**Economic Commission for Europe****Inland Transport Committee****World Forum for Harmonization of Vehicle Regulations****Working Party on Lighting and Light Signalling (GRE)****Sixty-Ninth session**

**Regulations Nos. 3, 4, 6, 7, 19, 23, 38, 65, 69, 70, 77, 87, 91, 98, 112, 113, and 119****Proposal for Supplement 5 to the 01 series of amendments to Regulation No. 98 (Headlamps equipped with gas-discharge light sources)****Submitted by the expert from Germany\***

8. The attached drawing shall demonstrate this stepwise process.

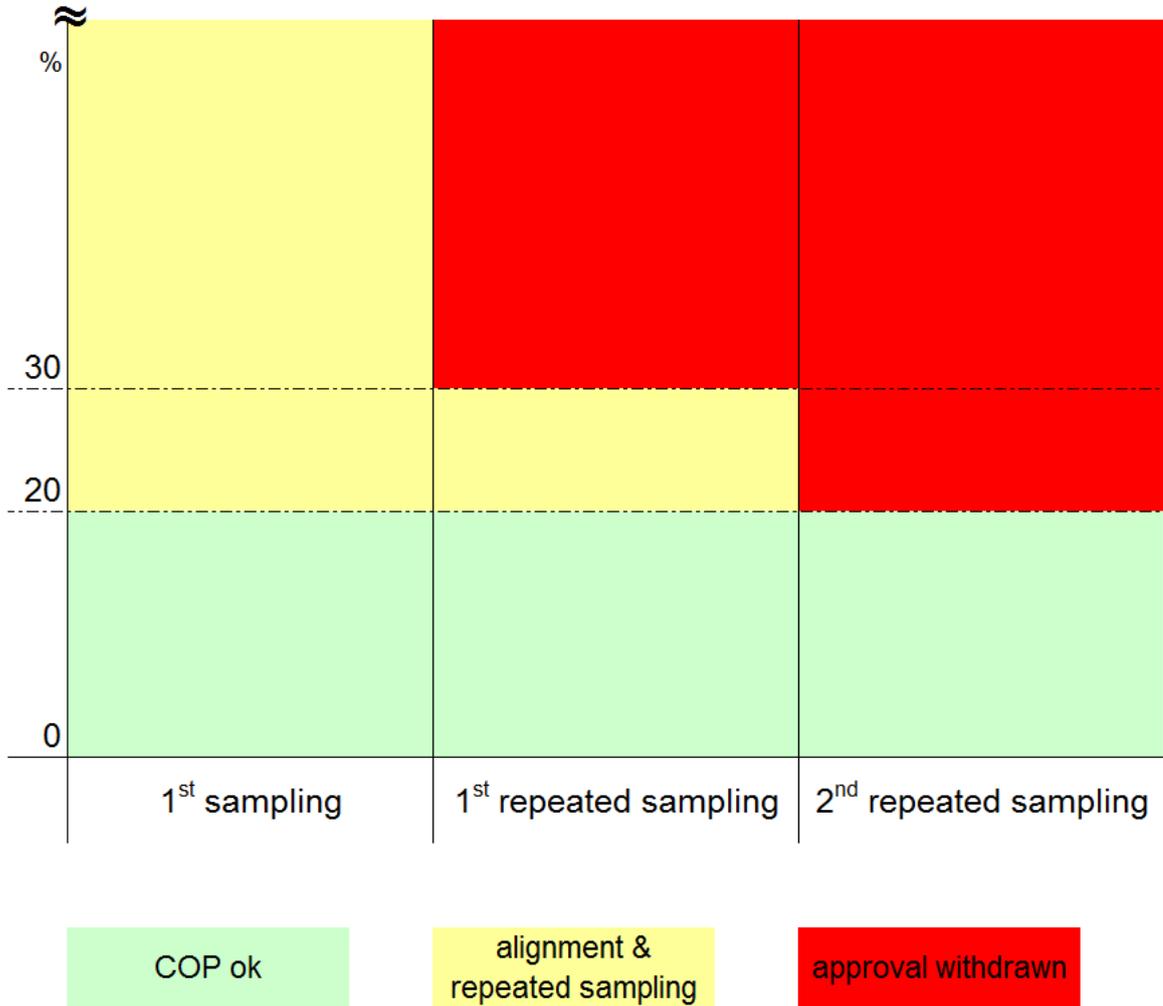
6. CoP is now described in a clear structured stepwise process (with limited steps), which gives the manufacturer the chance in the first step - in the case of deviations of more than 20 per cent - to align his production process. Also, the CoP process can be completed earlier when the first two samples are in the full specifications.

7. The proposal details the "third step" which defines the condition where the approval shall be withdrawn, when after the second repetition of this process the manufacturer was not in the position to "align" his production process in the correct way.
